RE: FCC Class II Permissive Change for FCC ID: ED9LMX9838
(Original grant date: 02/08/2007)
Applicant: Texas Instruments

This is to request a Class II Permissive Change for FCC ID: ED9LMX9838 originally granted on 02/08/2007.

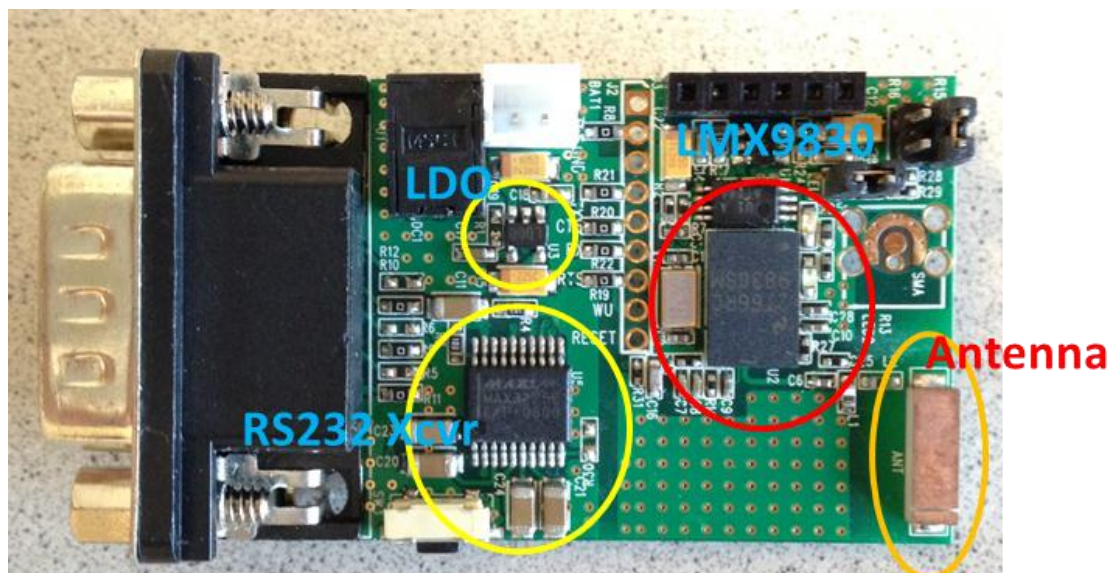
The major change filed under this application is that we moved the antenna of the LMX9838 outside on a PCB board, and named it the LMX9830DONGLE. The RF circuitry and baseband circuitry are identical. The only change is moving the antenna from inside the IC package to outside, and adding additional RS232 transceiver and LDO just for ease of wired connectivity.

The LMX9830DONGLE consists of the LMX9838 original circuitry and the external antenna shown in picture below. The additional RS232 transceiver and LDO are also marked, and they do not impact the RF circuitry in any way.

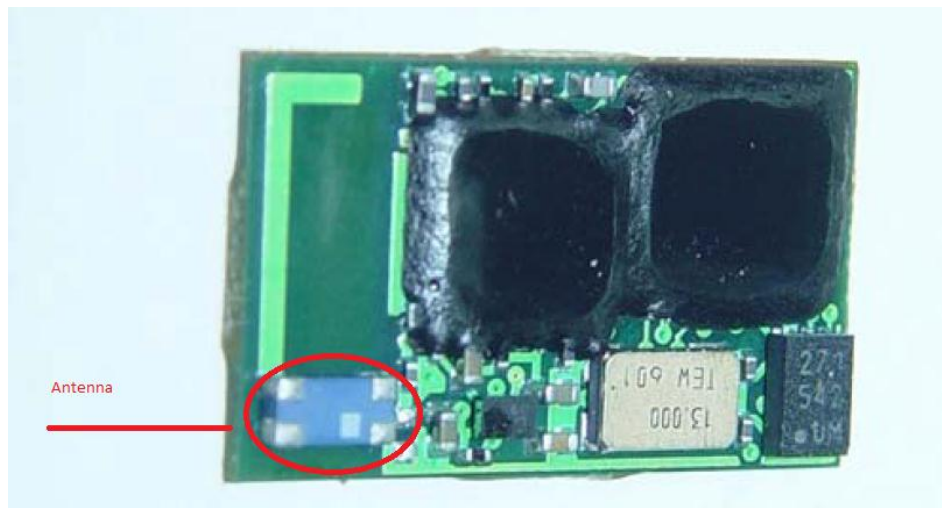
Below is the decapped picture of the LMX9838 IC. Compared with this, the IC on the LMX9830DONGLE has the identical radio and controller, and the only major component missing is the circled antenna, which is added externally to the LMX9830DONGLE.

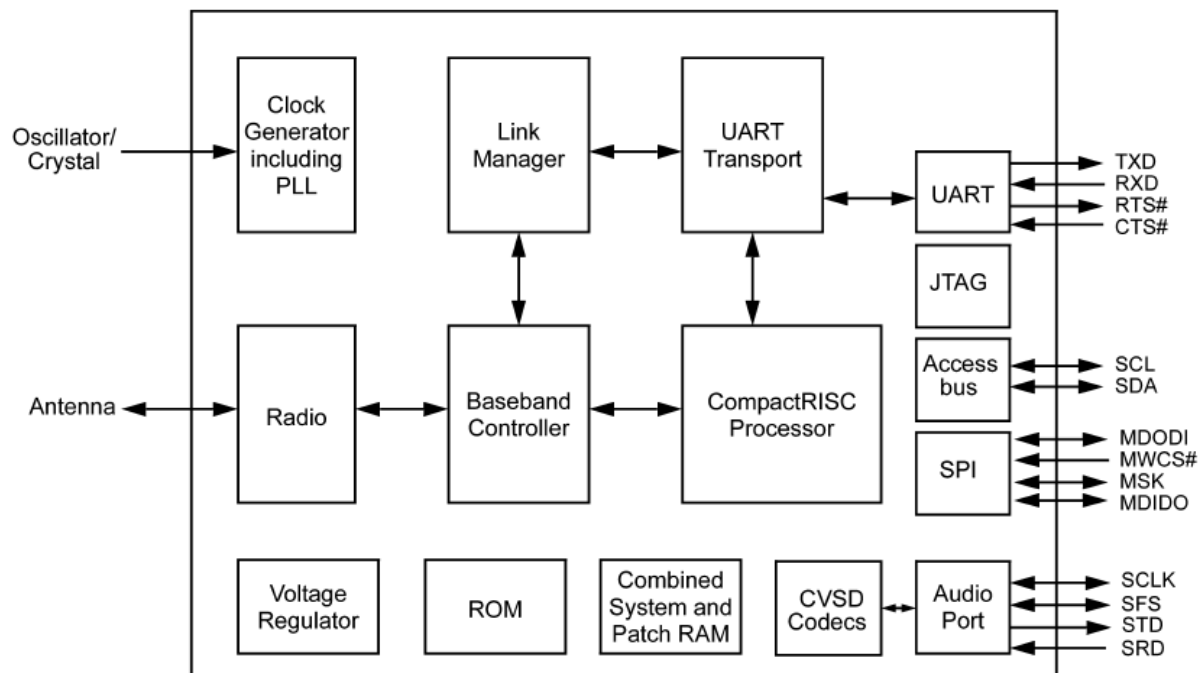
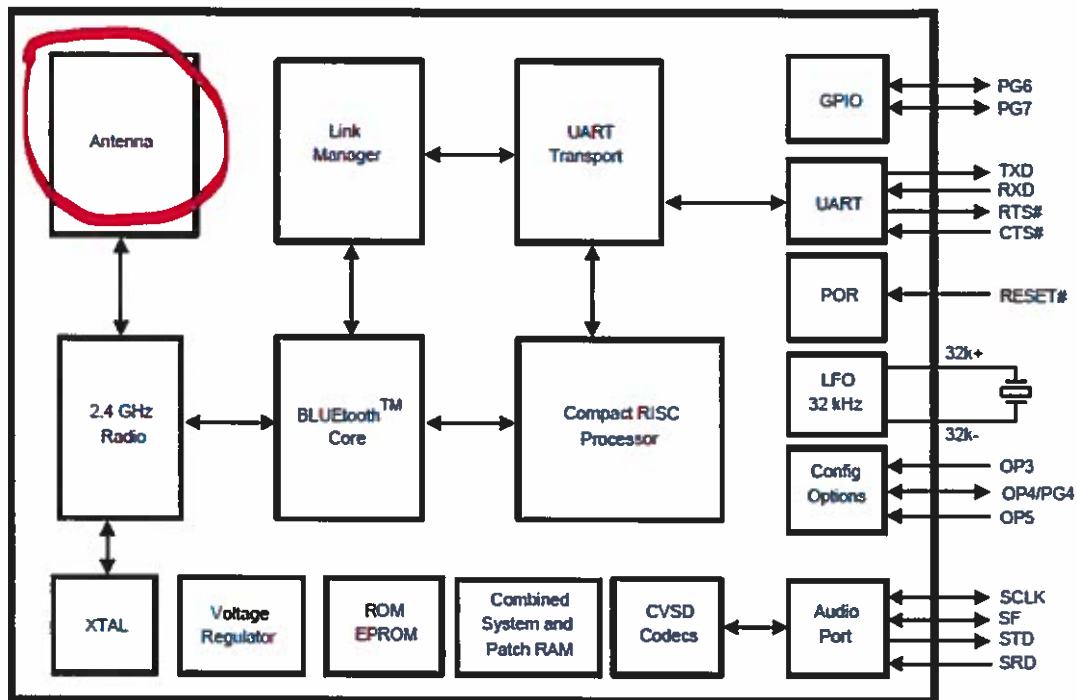
Another comparison of similarities and the antenna difference is shown below. The block diagram on this page is the LMX9830DONGLE IC, and the one on the next page is LMX9838. Other than the circled integrated antenna in the LMX9838 block diagram, most of the major components are identical. The antenna is included in the LMX9830 EVM externally.
